**ADDENDUM #1**

**Notice to Bidders:** This addendum forms a part of the Contract Documents, and modifies the original Bidding Documents for the: **King County Library System Covington Library Exterior Improvements** at 27100 164<sup>th</sup> Ave SE, Covington, WA, Project Manual and Drawings, and previous addenda, if any, as noted below. Acknowledge receipt of this Addendum in the space provided in the Form of Proposal. Failure to do so may subject the bidder to disqualification. It is the responsibility of the General Contractor submitting a bid to verify that all subcontractors from whom they receive sub-bids are in receipt of addenda for this project.

#### Sheet A2.01

AD  
1-1

## 1 Partial Roof Plan

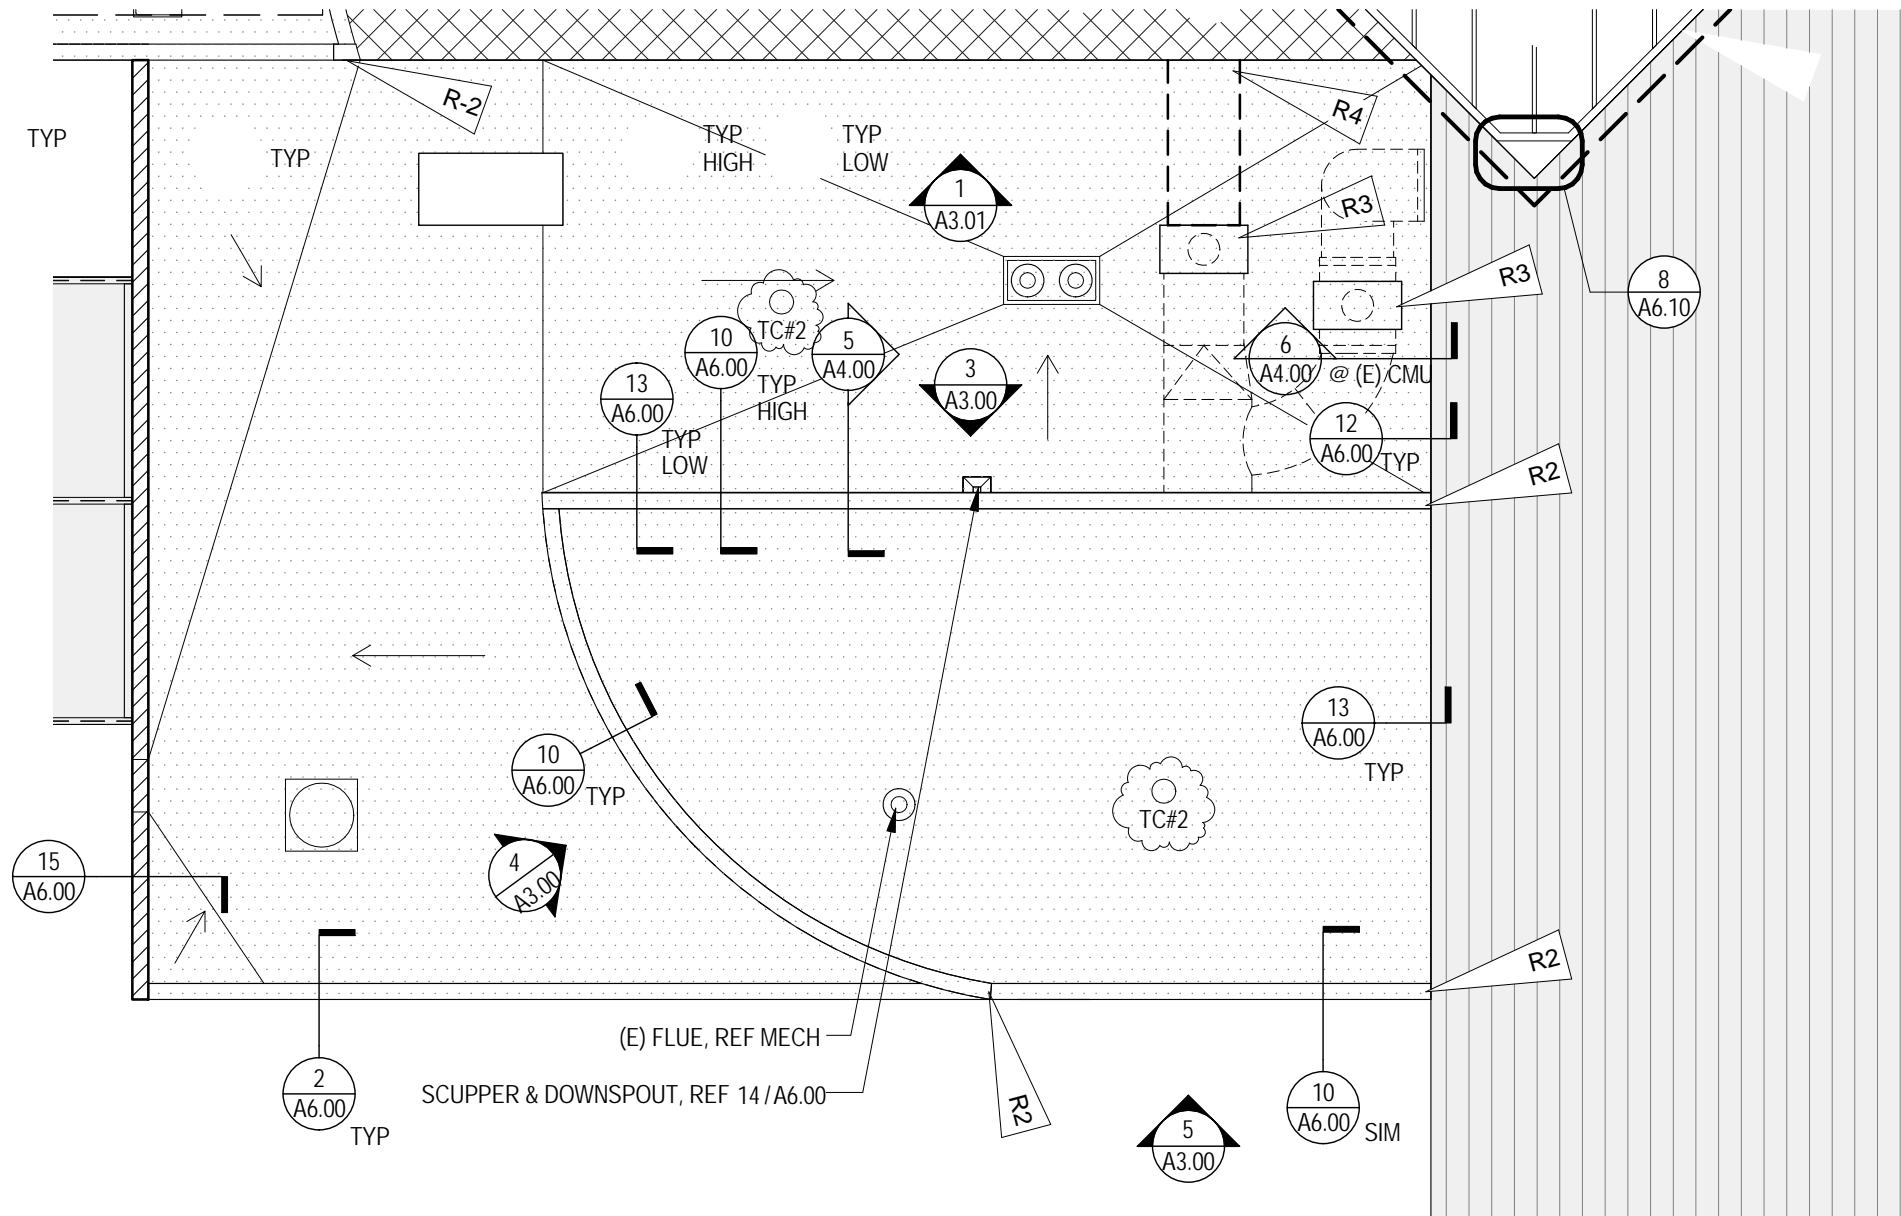
ADD Test core information of existing roofing per attached ASK-AD-1-1.

-  TC#1 TEST CORE #1 (APPROX LOCATION): EXISTING ROOFING: BUILT UP ROOF W/ GRANULATED CAPSHEET OVER 1/2" PERLITE OVER 1" RIGID INSULATION TAPERED 1/4" PER FOOT OVER 3" RIGID INSULATION OVER WOOD DECK
-  TC#2 TEST CORE #2 (APPROX LOCATION): EXISTING ROOFING: BUILT UP ROOF W/ SMOOTH CAPSHEET OVER 1/2" PERLITE OVER 1" RIGID INSULATION TAPERED 1/4" PER FOOT OVER 3" RIGID INSULATION OVER WOOD DECK
